Work Order ID 93308

Item Name: Gusset

ENGINEERING CHANGE NOTICE NO.		02937		SHEET 1 OF 1	
DWG NO. 647.1700	REV: NC	PREPARED BY J. JACKSON	DATE: 07/14/10	EFFECT ON DWG. <input type="checkbox"/> INC. <input checked="" type="checkbox"/> UNINC.	
DWG TITLE: SKID DEFLECTOR ASSY					
APPROVED BY: ENGR <i>[Signature]</i>	MFG <i>[Signature]</i>	QC <i>[Signature]</i>	EFF: CURRENT ORDER		
REASON: REVISED F/N 8 AND NOTE 3. ADDED INSPECTION DIMENSIONS TO DRAWING VIEWS.

**SKID DEFLECTOR ASSY**

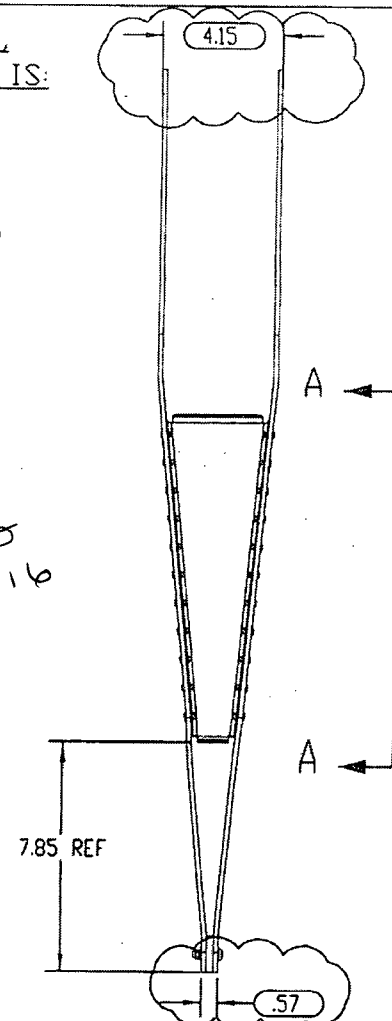
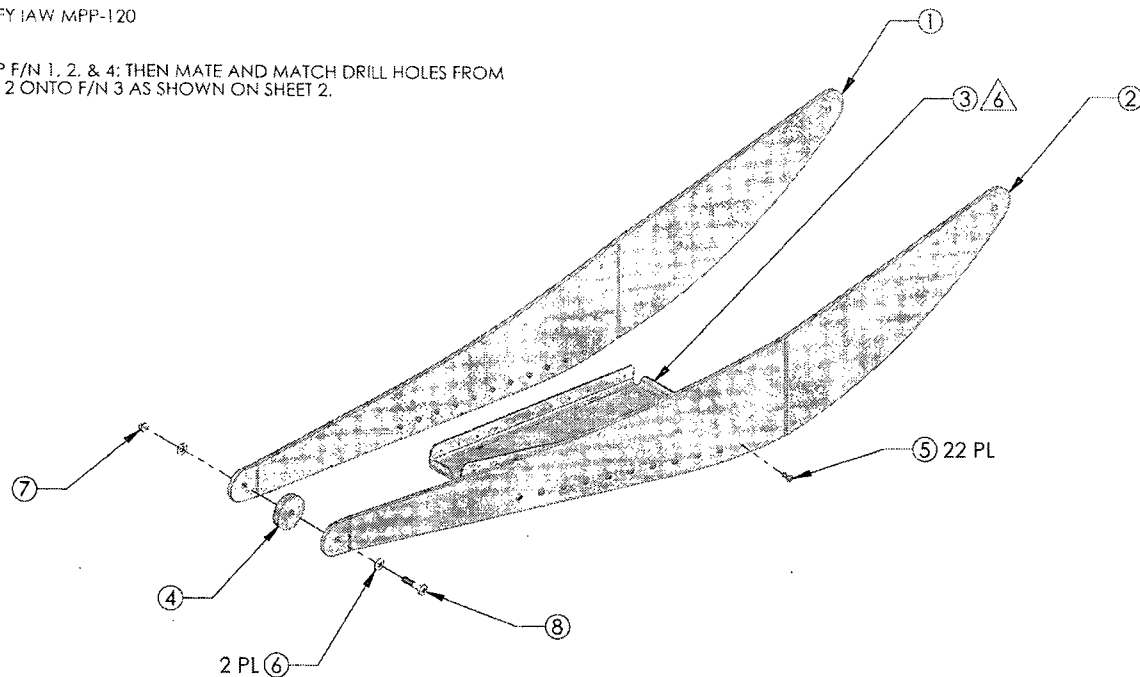
SHEET 1, ZONE A1 IS:

3 FINISH: HARD ANODIZE IAW MIL-A-8625 TYPE III CLASS 2, COLOR BLACK;  
PRETREAT PRC-DESOTO PR-148 ADHESION PROMOTER, COLOR BLUE;  
PRIME IAW MIL-P-23377J TYPE I CLASS N

- 1 MATERIAL: 7075-T6 ALUMINUM PER AMS-QQ-A-250/12
- 2 MATERIAL: 6061-T6 ALUMINUM BAR IAW AMS-QQ-A-250/11
- 3 FINISH: HARD ANODIZE IAW MIL-A-8625 TYPE III CLASS 2.  
COLOR BLACK: CARDINAL 4860-50 PRETREATMENT PRIMER:  
PRIME IAW MIL-P-23377J TYPE I CLASS N
- 4 DEBURR AND BREAK ALL SHARP EDGES
- 5 IDENTIFY IAW MPP-120
- 6 CLAMP F/N 1, 2, & 4; THEN MATE AND MATCH DRILL HOLES FROM  
F/N 1 & 2 ONTO F/N 3 AS SHOWN ON SHEET 2.
